PUBLIC MEETING TOWN OF HUDSON, NH **FEBRUARY 26, 2014**

Boyer Site Plan - 156 Lowell Road

PLAN UNDER REVIEW ENTITLED: Non-Residential Site Plan Boyer Site, 156 Lowell Rd. Map 204 Lot 075, Hudson, NH, prepared by Keach-Nordstrom Associates, Inc., dated: Nov. 12, 2013, latest revision date Feb. 17, 2014, consisting of Sheets 1 - 11 and Notes 1 – 23 (said plans are attached hereto).

Boyer Site Plan Tax Map 204, Lot 75 KNA#06-0808-2

NOT TO SCALE

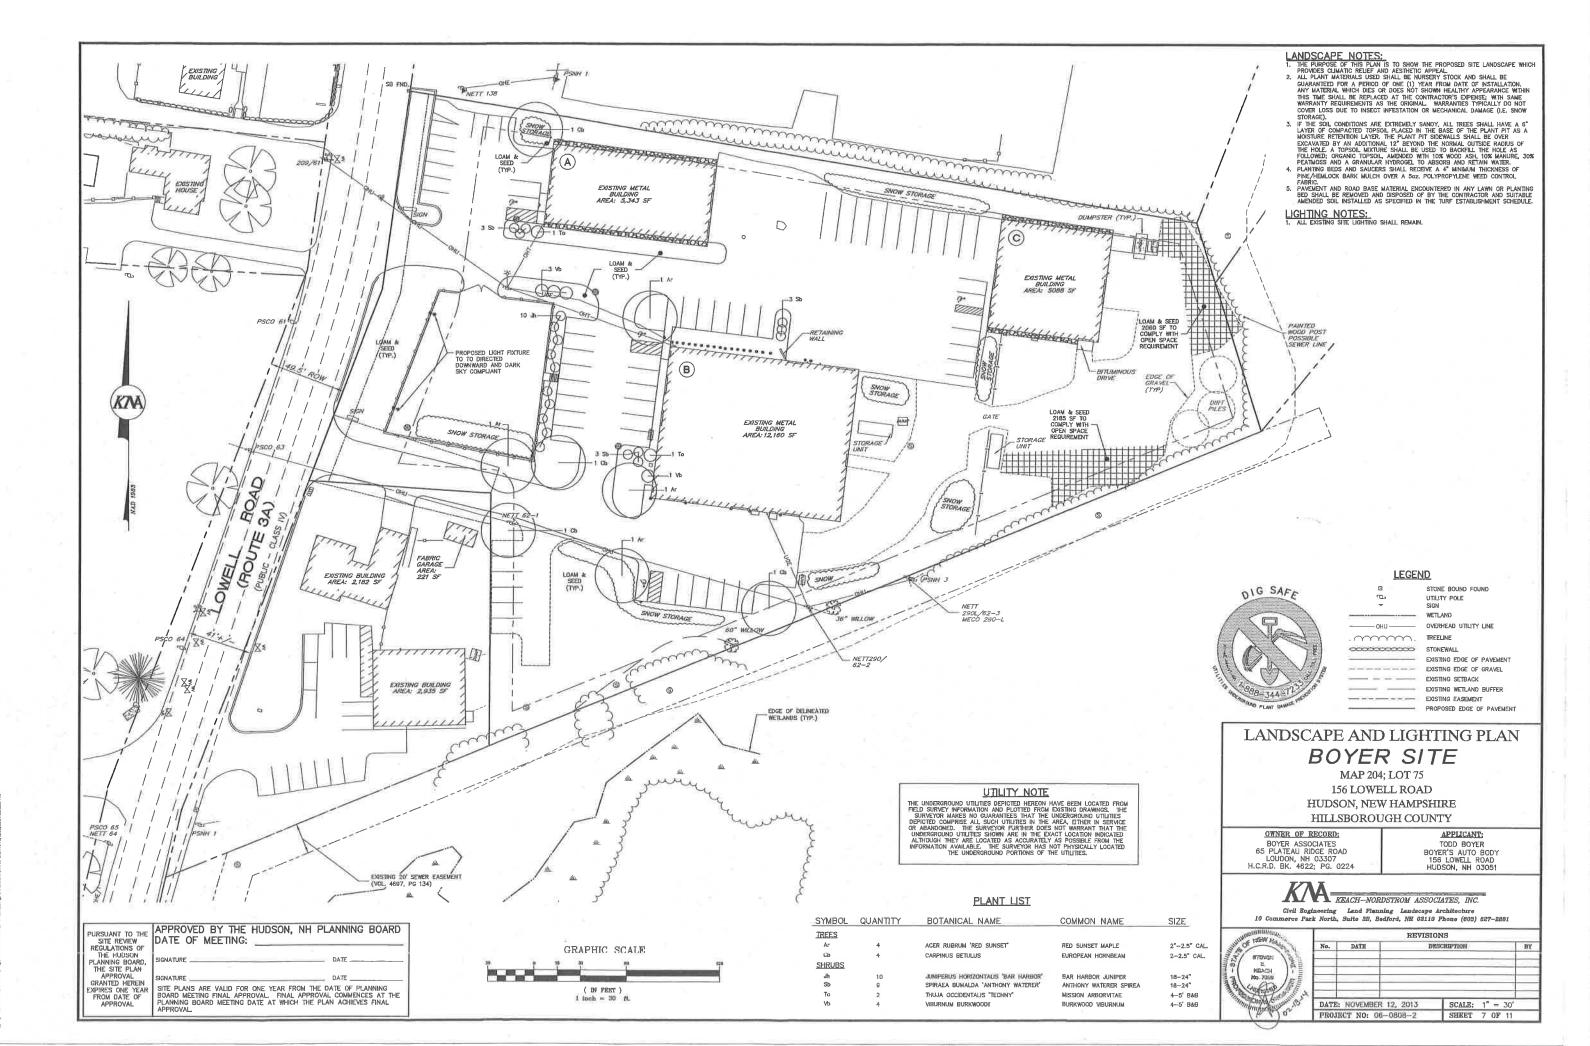
a. HR 275-8.B. (35) The applicant has shown four handicap parking areas and has provided corresponding details; however, the handicap van accessible sign location(s) are not shown on the plans or in the handicap striping detail. The applicant should also label American Disability Act (ADA) compliant building entrances and provide additional spot grades and ramp details, if necessary. (We were unable to find any ramp detail on the plan set.)

Signs have been added. All building entrances are existing and do not have ramps, therefore a ramp detail is not shown.
